1704 Latton Water Treatment Works Tender Change Control Tracker

Issue 01 - 25 April 2025 (work in progress issue)
Issue 02 - 02 May 2025
Issue 03 - 02 May 2025

project	1704	project	Latton Water Treatment Works
document	D07 - 03	title	Tender Change Control Tracker
issue date	02/05/2025	scales shown @ A3

12. Add 2 columns to GF plan, one to continue through first floor.

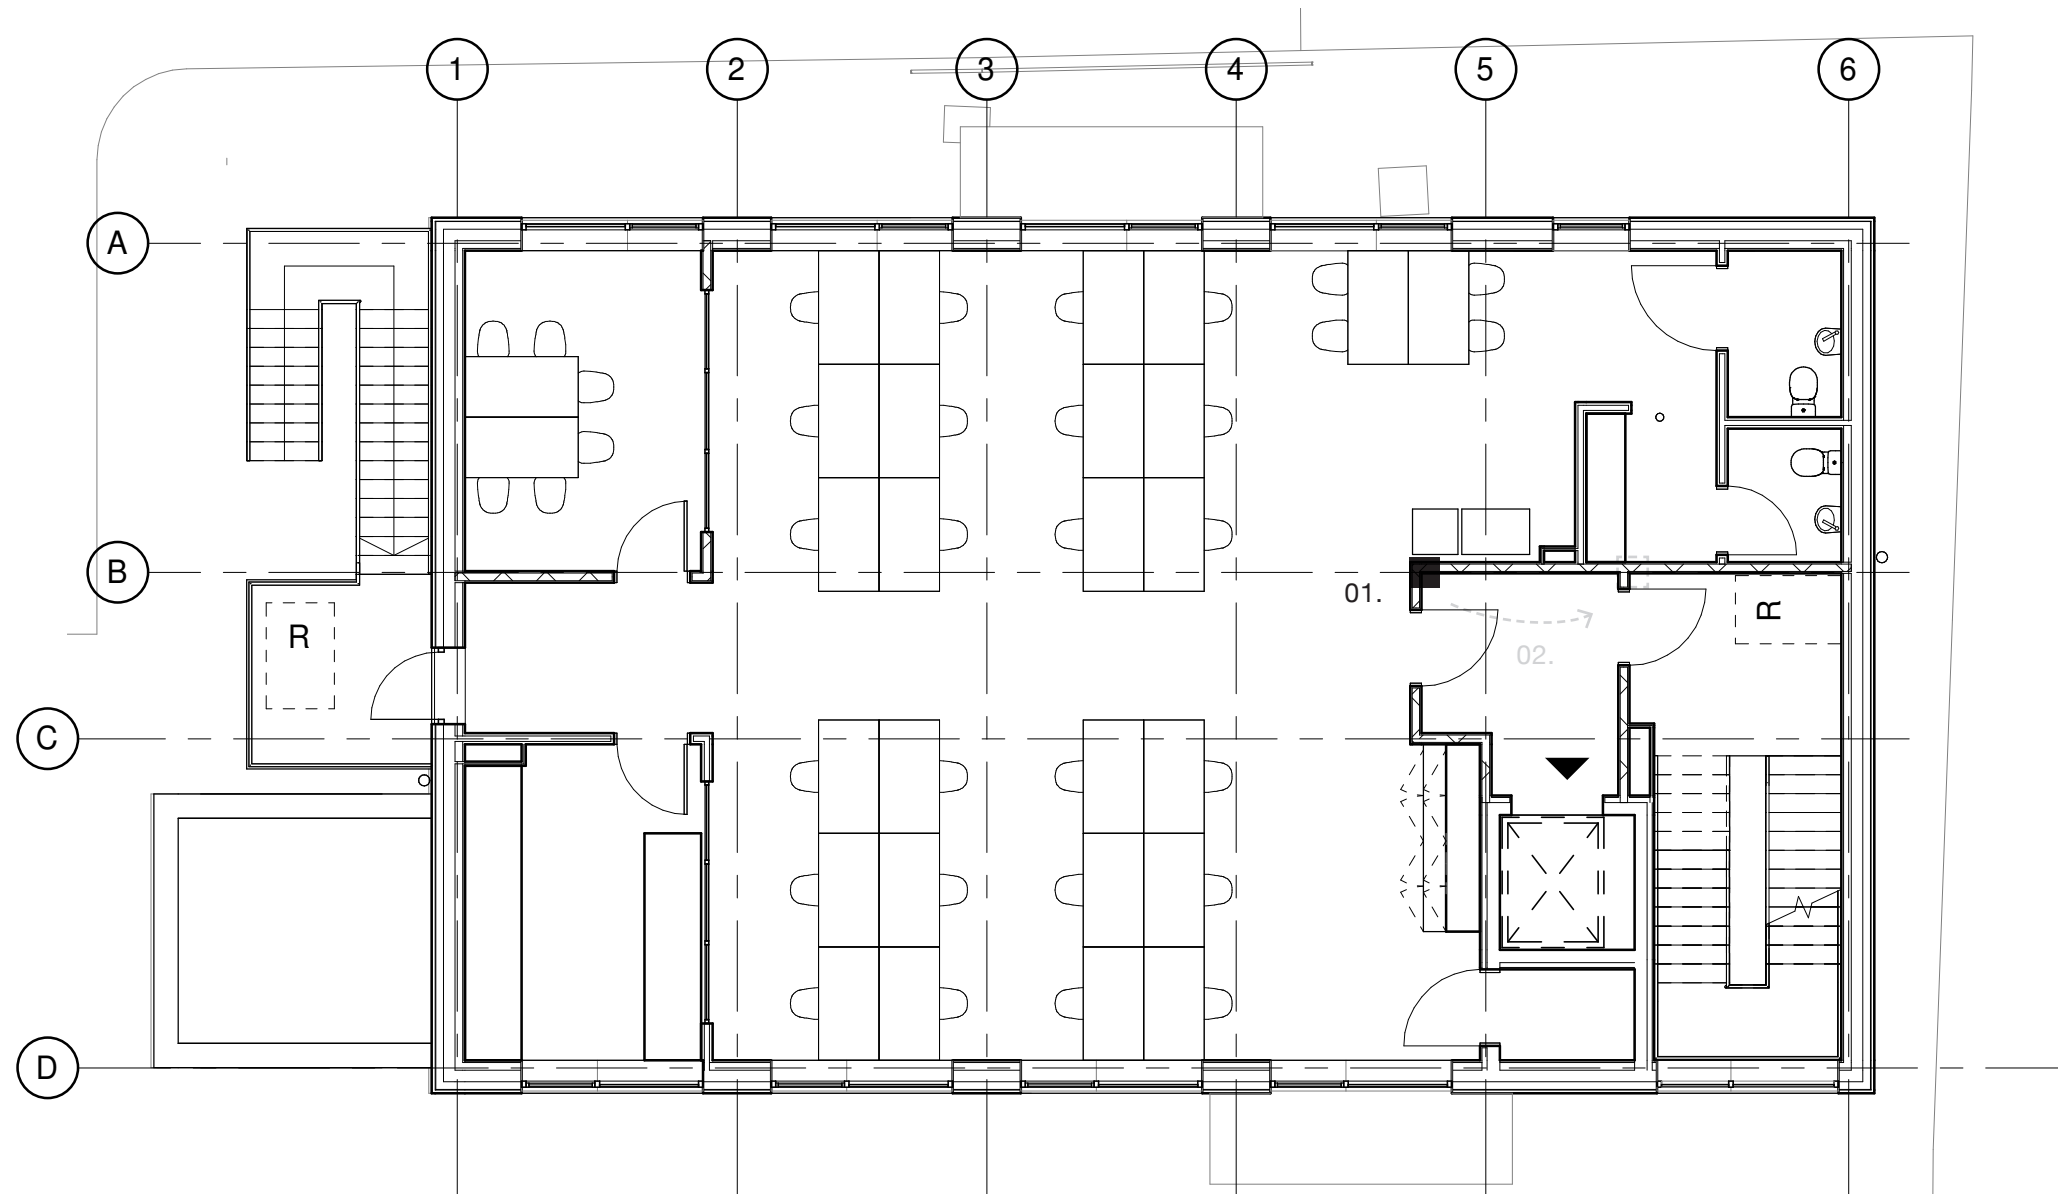
- 01. Add steel 2 columns to GF layout, one to continue to FF.
- 02. Consider extending span of beam to integrate column position with protected stair enclosure.
- 03. To be read in conjunction with amendments 6 and 7.

Structural design.

Change agreed as shown in structural design, 25/04/2025.

13. 1.2m wide access path added to S.E. side of building, land grades down, assumed max level change 400mm.

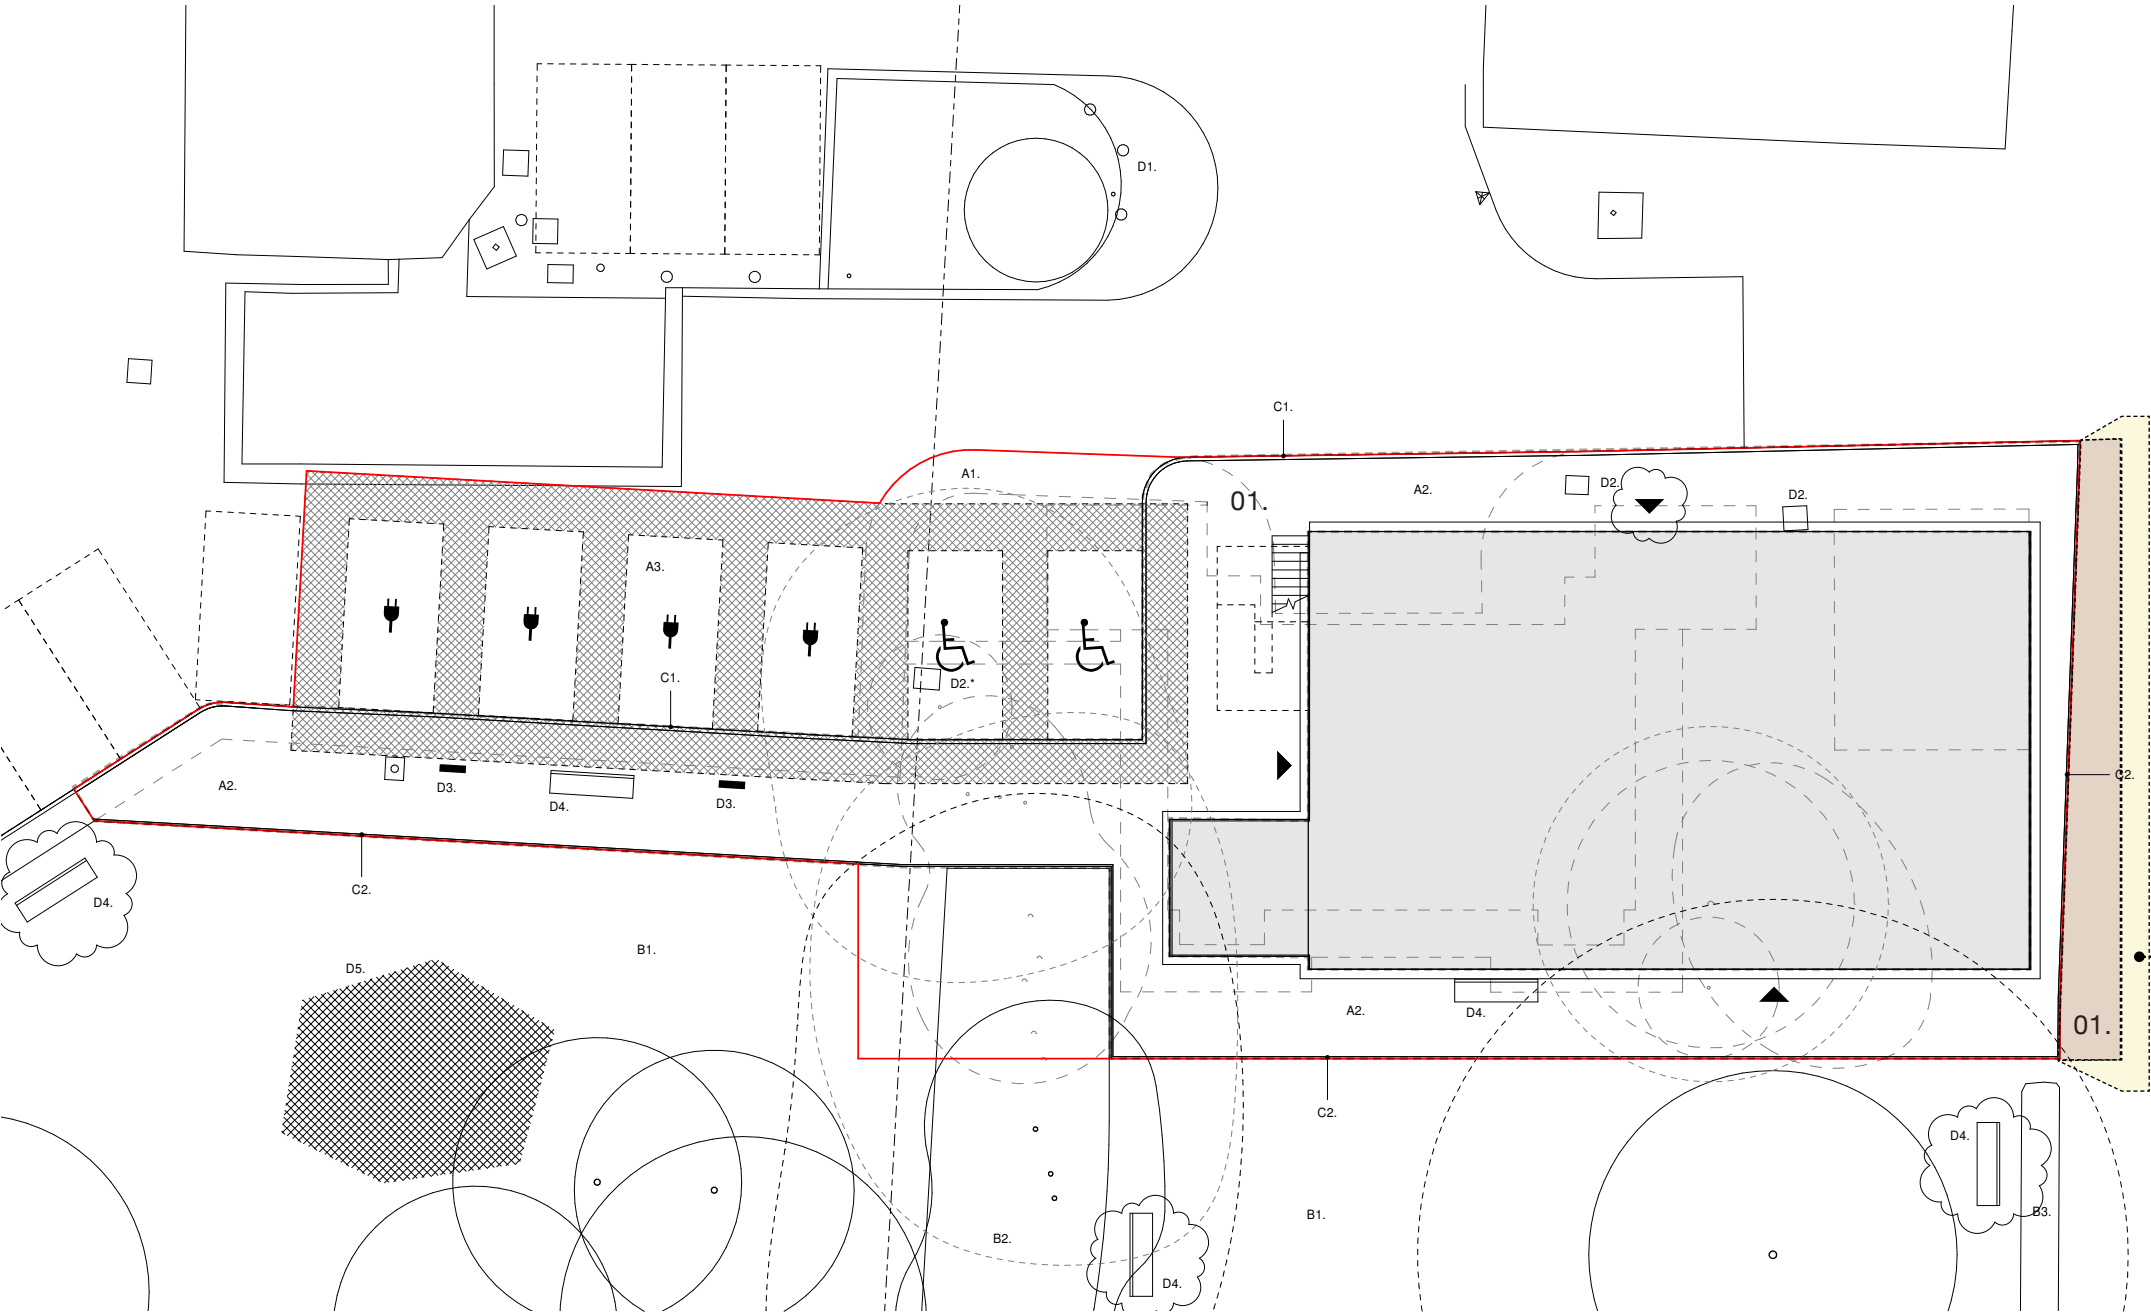
- 01. Footpath added to south-est side of building, 1.2m wide.
- 02. Land beyond graded down to existing level (assume max. 400mm).

Civils design / client instruction.

Confirmed 02/05/2025.

14. 30 minute fire compartment added to records store.

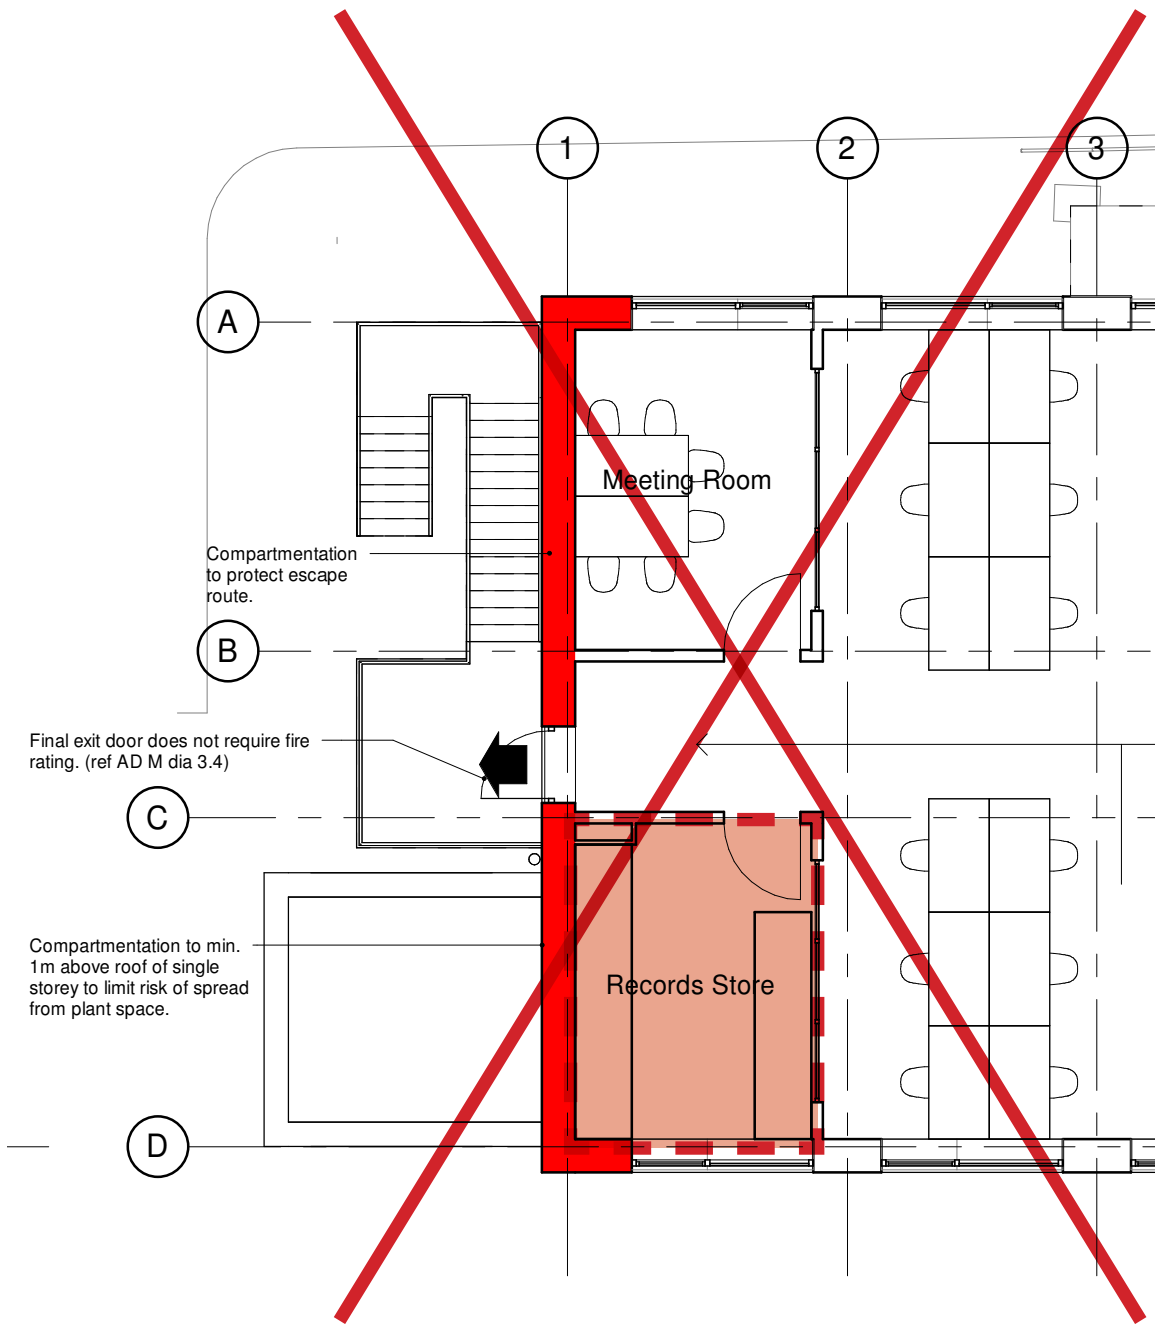
01. Addition of fire compartment line around records store including door and firestopping. Change use of space to office.

Fire engineer design.

Reviewed on site w/c 02/05/2025. Likely paper records will be disposed of prior to building completion. Change use of space to office. Some storage provision can be allowed for in bottle store. No compartmentation thought to be required - tbc Fire Engineer.

15. Internal glazed screens amended to double glazed upvc framed windows with integral blinds and 1.1m high sills, head height 2.1m AFL..

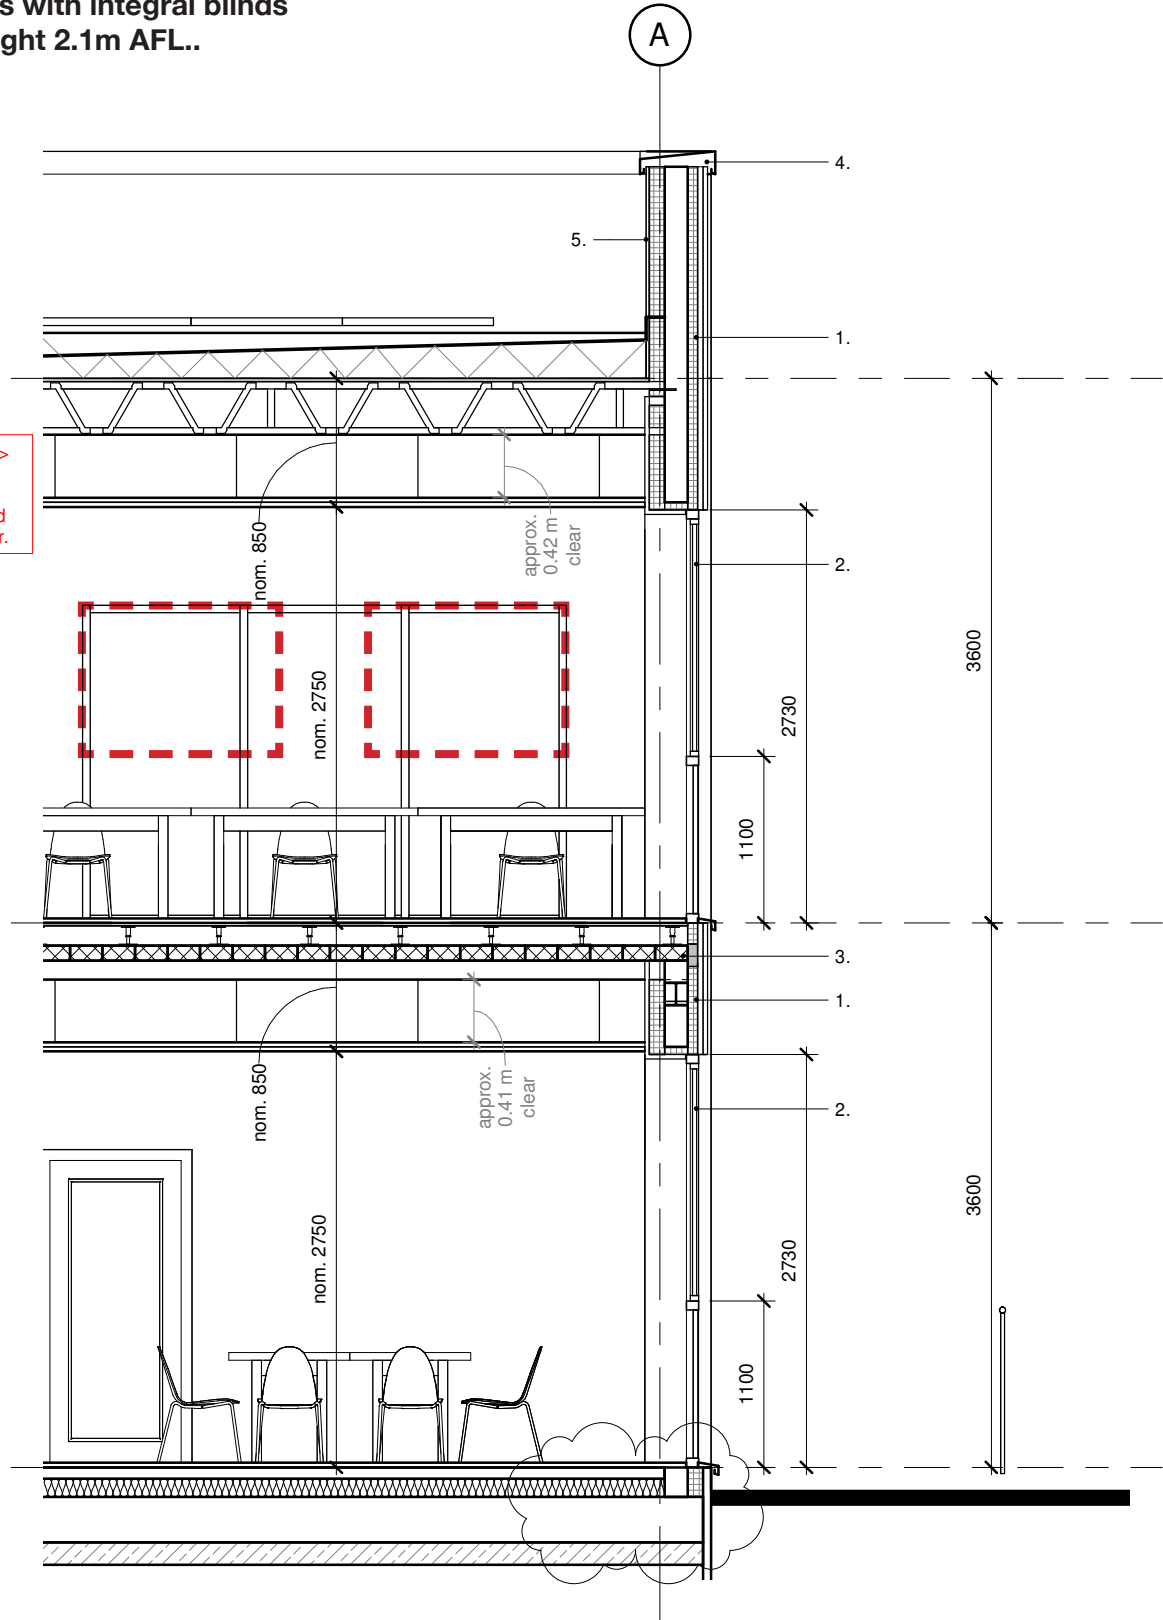
First floor ceiling void > 0.8m deep - possible requirement for void detection to be agreed with building inspector.

01. Glazed screens to meeting room and record store amended to UPVC double glazed screens with integral blinds, 1025mm high cill, head height 2.1m above floor level, 450mm wall panel between.

Client instruction.

Agreed 02/05/2025.
